**Re: ENERGY STAR for Windows, Doors, and Skylights – Version 6.0 Proposed Product Specifications**

On behalf of the 300 member companies of the American Architectural Manufacturers Association (AAMA) and the estimated 110,000 employees directly impacted by the proposed revisions to the ENERGY STAR program, we offer the following comments in response to Version 6.0.draft 2

**Table 5: Average Incremental Product Costs**

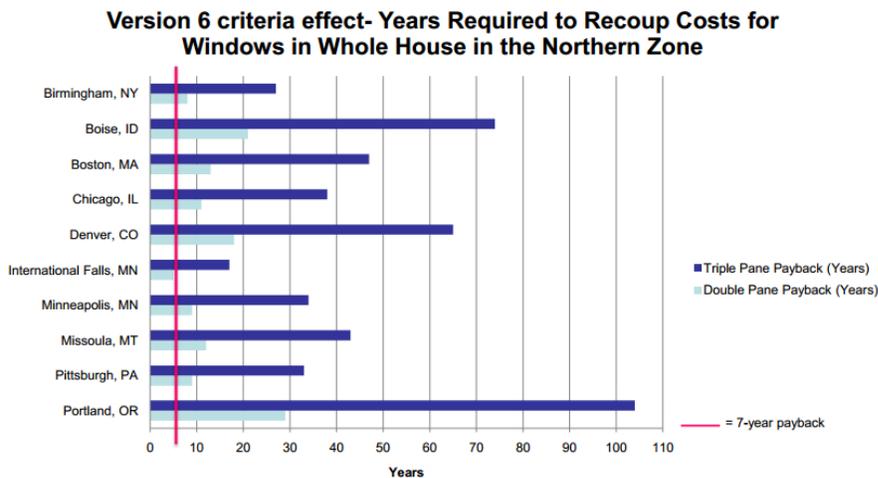
To accurately report incremental product cost effectiveness throughout the Northern Climate Zone, any analysis must include triple-pane windows in developing and correctly reflecting payback conclusions.

The exclusion of triple-pane windows in the EPA cost analysis, severely understates the conclusions made throughout the “Cost-Effectiveness” portion of Draft 1. Without the inclusion of data on triple-pane windows in Table 5, consumers will be misled on product payback and cost-effectiveness.

Based on an AAMA survey, the average cost increase over Best Selling ENERGY STAR windows resulted in more than doubling the estimated payback time. **In fact, the AAMA data proves the average cost to be more than double the EPA estimated \$34.00 cost increase.**
